# Access Compliance Report

## Public Rights-of-Way

### (Pedestrian Signals)

Intersection ID: N/A	Main Street:	Cross Street: N/A	Location: N/A
ADA ID: 879FF5252D71	Signal Type: One Push Button-Non APS	Overall Compliance: No	Severity Score: BTN 1: N/A BTN 2: N/A No BTN: N/A
Codes/Mitigation Info/Possible Solution		Field Measurements/Component Compliance

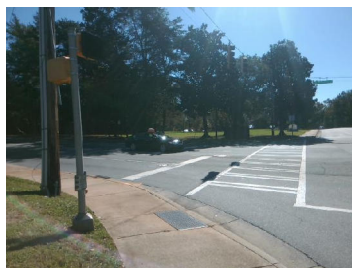
PROW/ADA: TMUTCD 4e.08, R404.2, R406.2, R404.7.3

Possible Solutions: Replace Signal Push Button With APS Button on New Post. Remove & Relocate Sign.
